City of Fayetteville Staff Review Form

ADM 19-6816: Administrative Item (380 N. COLLEGE AVE./OZARK NATURAL FOOD CO-OP, 485): Submitted by FLINTLOCK LTD., CO. for property located at 380 N. COLLEGE AVE. The property is zoned MSC, MAIN STREET CENTER and contains approximately 2.17 acres. The request is for no dedication of Master Street Plan right-of-way associated with a small site improvement plan.

SUBJECT: **ADM 19-6816: Administrative Item (380 N. COLLEGE AVE./OZARK NATURAL FOOD CO-OP, 485):** Submitted by FLINTLOCK LTD., CO. for property located at 380 N. COLLEGE AVE. The property is zoned MSC, MAIN STREET CENTER and contains approximately 2.17 acres. The request is for no dedication of Master Street Plan right-of-way associated with a small site improvement plan.

SUBJECT: **VAR 19-6816: Variance (380 N. COLLEGE AVE./OZARK NATURAL FOOD CO-OP, 485):** Submitted by FLINTLOCK LTD., CO. for property located at 380 N. COLLEGE AVE. The property is zoned MSC, MAIN STREET CENTER and contains approximately 2.17 acres. The request is for variances to the parking lot, building design, landscape, and screening requirements.

**19-6816
EXHIBIT 'A'**

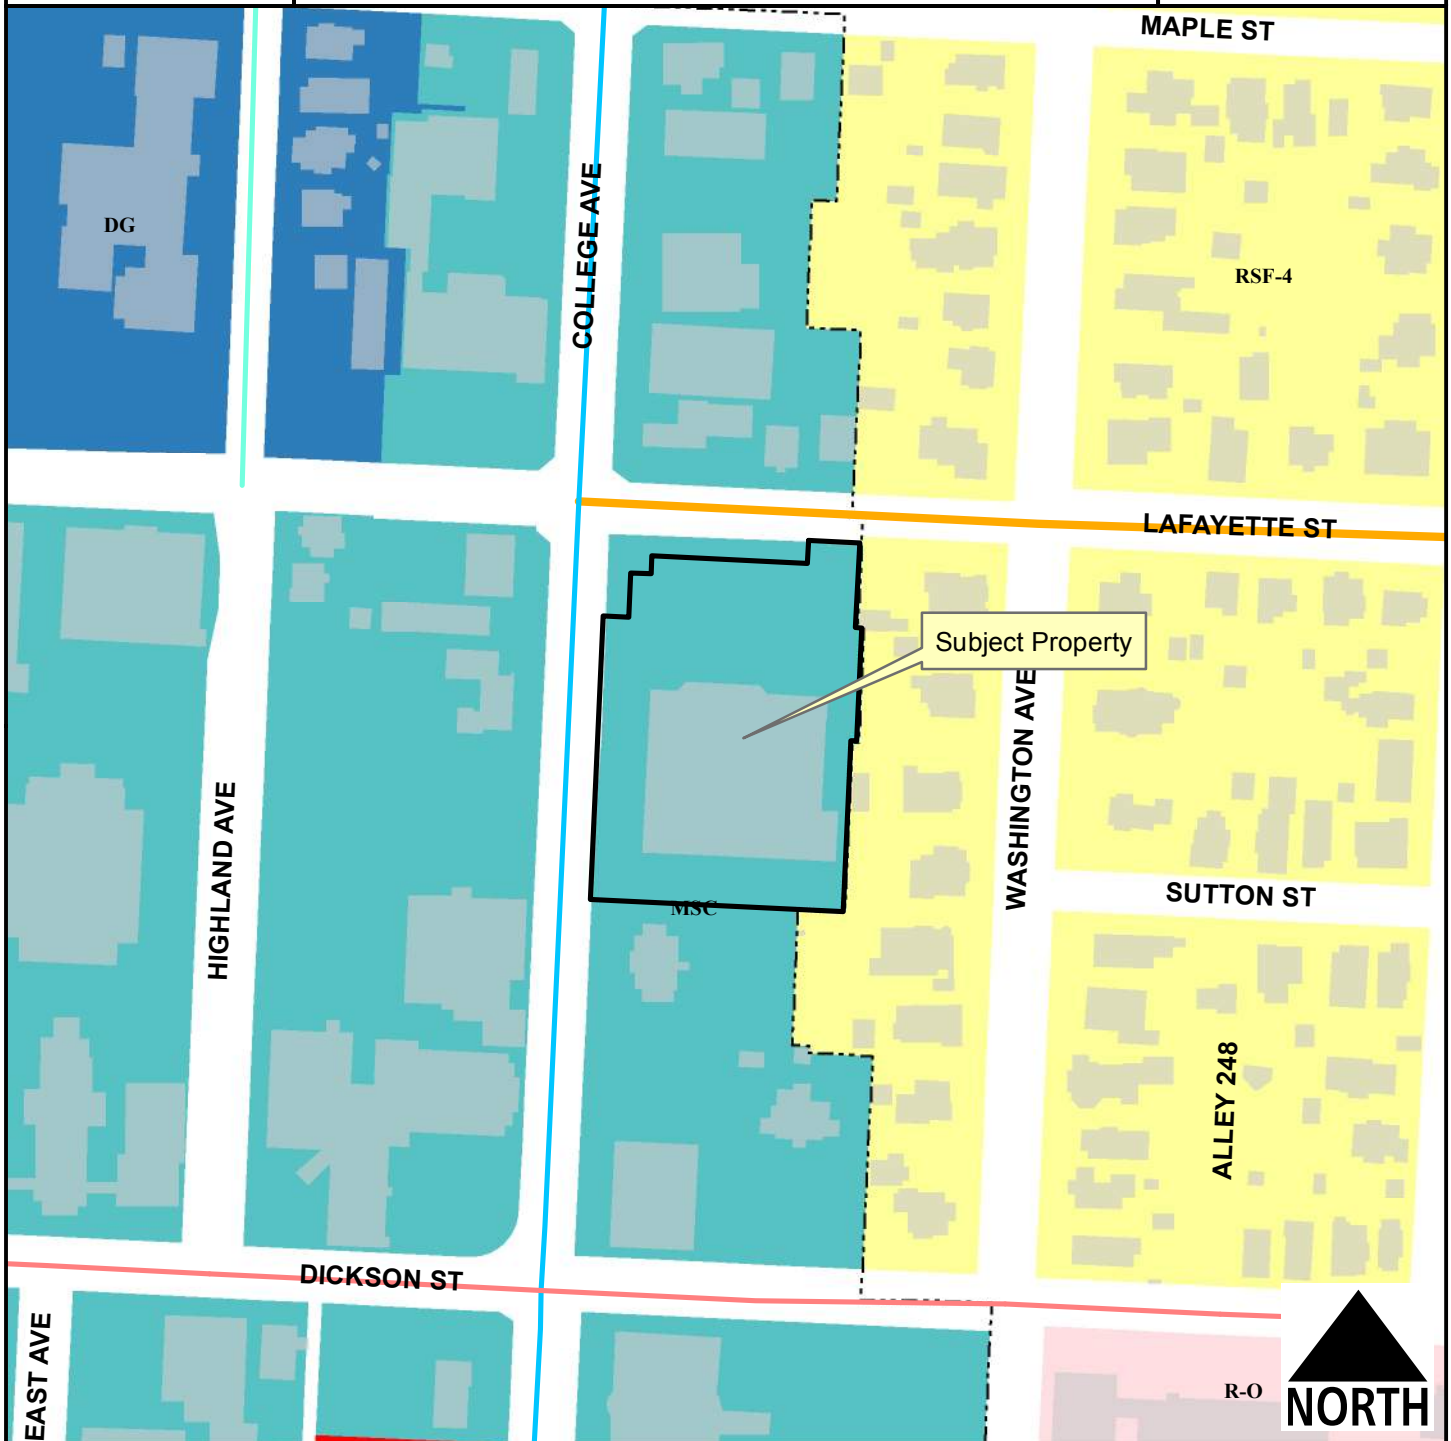
Planning Commission and staff recommend approval of a request to accept no right-of-way dedication as depicted in Exhibits 'A' and 'B'

Request: The applicant has proposed to redevelop the subject property (SIP 19-6815), which requires right-of-way dedication where current right-of-way widths are insufficient to meet the Master Street Plan pursuant to UDC 166.04(B)(3)(a). For the applicant's property, required dedication includes 35 feet from the centerline of Lafayette Street with consideration for its classification as a Collector Street in sufficient proximity to a signalized intersection to warrant a turn lane. The applicant proposes no dedication of right-of-way.

recommends altering the portion of Lafayette Street along the subject property's frontage from a Collector Street to a Downtown/Urban Street. Staff review of the existing Lafayette Street right-of-way from-centerline indicates that it can support two drive lanes and a turn lane, along with the eight-foot urban sidewalk and furniture zone associated with the proposed Downtown/Urban Street section.

6. Planning Commission determination of no dedication of right-of-way. *Staff recommends in favor of the request, finding that the existing right-of-way is consistent with the proposed re-classification of Lafayette Street from a Collector (Intersection) Street to an Downtown/Urban Street in the draft Master Street Plan.*

CURB CUT VARIANCE REQUEST : PLAN DIAGRAM

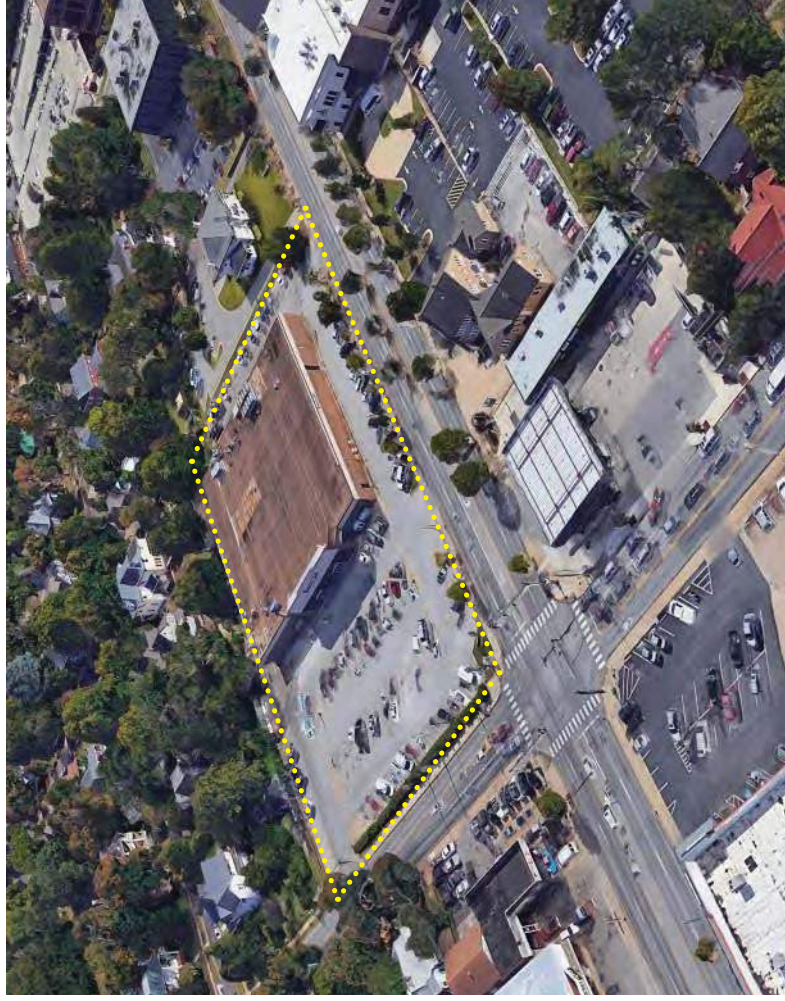
Considering this, Planning and Engineering staff have reviewed each of the three existing curb cuts and are recommending in favor of a variance for the nonconforming access point on Lafayette and the southern access point on College Avenue. Although both curb cuts are near off-site adjacent curb cuts, the low traffic of the nearby residential driveway on Lafayette and the one-way nature of the driveway on adjacent property on College Avenue represent a lower potential for vehicular conflict than accessing either street in closer proximity to the intersection of Lafayette and College.

As to the applicant's comment that the northern curb cut is the ideal access point for deliveries, staff's findings indicate that Lafayette may be more appropriate. Although College is possibly the main point of approach for delivery trucks, Engineering staff review of entrance and back-up movements for a standard semi-truck with a 53-foot trailer show entering the subject property from College is not feasible from the right lane given the curb cut width and new structures proposed near this entrance. On the other hand, entrance in to the subject property from Lafayette using the existing curb cut can accommodate a semi-truck and trailer.

3. Planning Commission determination of a variance of UDC 166.08(F)(2), access management standards, to allow the existing northern driveway on College Avenue to remain in its current location. *Staff recommends that this request be denied based on the findings discussed in this staff report; and*

PLANNING COMMISSION ACTION: Required <u>YES</u>			
Date: <u>November 13, 2018</u>	<input type="checkbox"/> Tabled	<input checked="" type="checkbox"/> Approved	<input type="checkbox"/> Denied
Motion: Scroggin, modifying Condition #3 to allow the northern College Avenue curb cut to remain as a right-in, right-out access.			
Second: Autry			
Vote: 6-0-1, Belden recused

VAR 19-6816
Existing
Site Plan

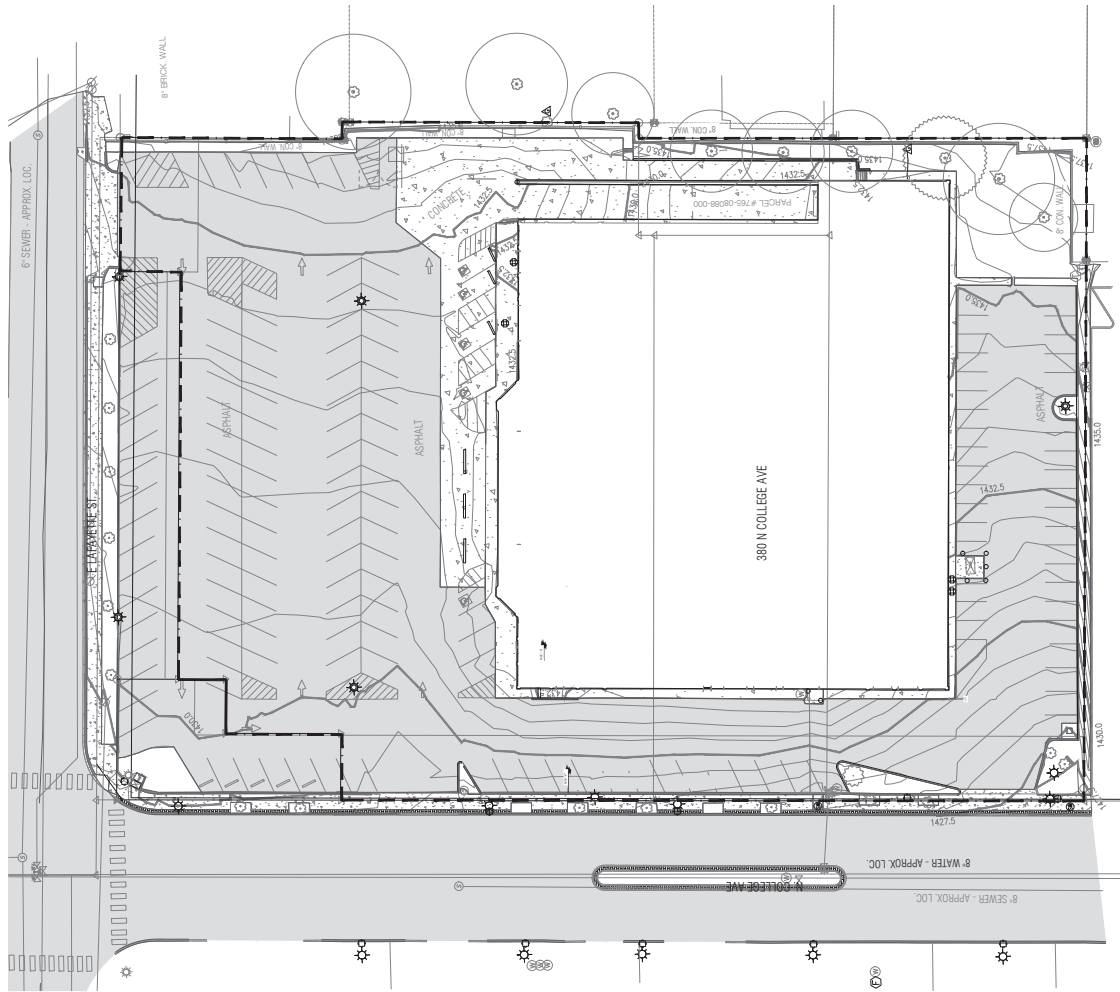
- *Staff Recommendation: With due consideration for the grade changes between portions of the subject property and the lot to the south, staff maintains that it is critical to the streetscape fabric of College Avenue/71B to encourage opportunities for cross access. Future development of the property to the south may create a condition where cross access is viable, possibly eliminating one of the two existing curb cuts within approximately 20 feet of each other.*

- *Staff Recommendation: Staff recommends in favor of the request, finding that the existing structure has utilized unscreened, roof-mounted screening since its construction in 1968. Given the applicant's proposal does not propose structural changes to the building beyond the addition of glazing and modification of materials, staff does not find the requirement for a parapet wall or other visual barrier to be commensurate to the project's scope.*

- *Staff Recommendation: Staff finds the applicant's request to conflict with the parking lot design ordinance's intent and purpose to create safe and efficient circulation for both vehicles and pedestrians. Staff does not support placement of pedestrians within parking lot driveways as proposed by the applicant, particularly along driveways that are adjacent to high-volume streets with the potential for frequent vehicle entries and exits. Further, staff does not find the proposal for an applied pavement marking to represent adequate protection and separation between vehicles and pedestrians. When pedestrians are routed in to drive aisles, not across them, it is generally in association with a raised walkway or, failing that, post delineators, bollards, or other physical cues to vehicles. Accordingly, staff recommends denial of the request as proposed, but would support allowing the Lafayette Street and Northern College Avenue curb cut widths to remain for truck access if pedestrian improvements were made outside of the drive aisle, or within the drive aisle as an elevated path.*

The applicant is requesting a waiver of the interior landscape requirement "Option 2 Tree Island" to be placed at a rate of one per 12 spaces along the southernmost row of parking. There are 14 parking spaces along the southernmost row which would require one tree island. Providing a new island in this space eliminates much needed parking for a project that has lost 45% of the existing parking spaces.

On the South side of the property is an existing narrow lawn that separates the parking from the adjacent parking on the neighboring property. The lawn area is approximately 5' wide with the property line running down the middle. This is an existing condition. On the East side of the property is an existing 6' high wooden fence which has been in place for many years to screen the parking lot from the adjacent residences. Additional screening would require demolition of a large portion of an existing concrete walkway. Urban Forestry recommends approval of this variance request for these three subsections of code for perimeter landscape requirements.

- In favor of cross access to the south, that may be parked until the time the neighbors to the south want to connect;
- In favor of the variance to not approve rooftop mechanical;
- In favor of the lesser dedication of right-of-way as proposed by the applicant and added as a determination at the meeting by staff;
- In favor of the driveway variance as requested, requiring that a raised additional element be incorporated into the driveway design to notify drivers of the pedestrian access in the driveway; and
- The fence along the eastern property line shall be substantially rebuilt with a six-foot tall fence from the northern property line until it is parallel to the north facade of the primary structure, then becoming eight-foot tall to the south of the building
